**NCDOT Project SP 2007-2
March 2011**

***Hollow Core Beam Bridge #20
over Broad Creek on SR 1124 in
Carteret County, North Carolina***

Review of Hollow Core Beam Bridge #20 over Broad Creek

Figure 4 Grout Pictures

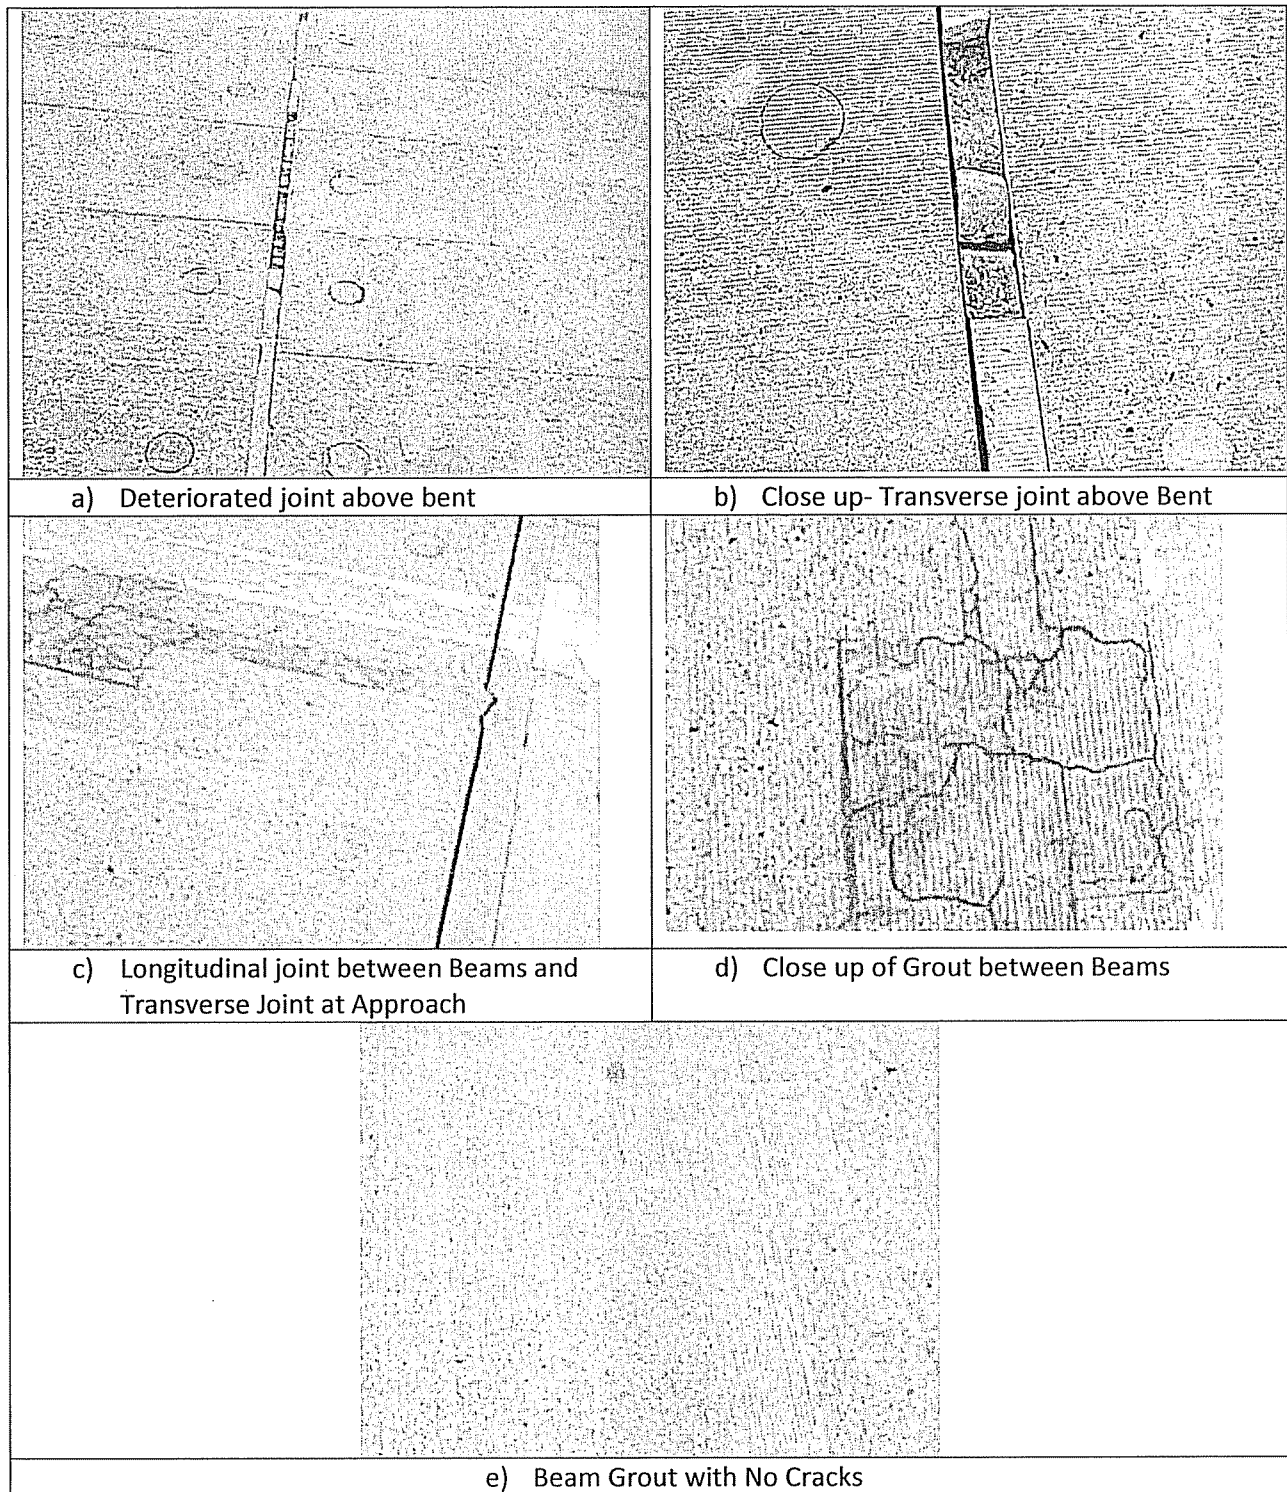
Issues are evident related to performance of the grout used both for filling voids longitudinally between beams and at the transitions between the approach and over the pile caps. Once again, the performance of grout was inconsistent.

- Figure 4 (a) and (b) show issues with the transverse joints between the beam slabs.
- Figure 4 (c) and (d) show issues with the transverse joint where the approach meets the beam slab and also with a longitudinal joint between beams.
- Figure 4 (e) shows a similar joint to 4(d) with no cracking evident.

The inconsistency of the cracking in the longitudinal joints between beams may indicate an issue with mix or material consistency. As far as the transverse joints, root cause issues appear to relate to joint design, material specification or both.
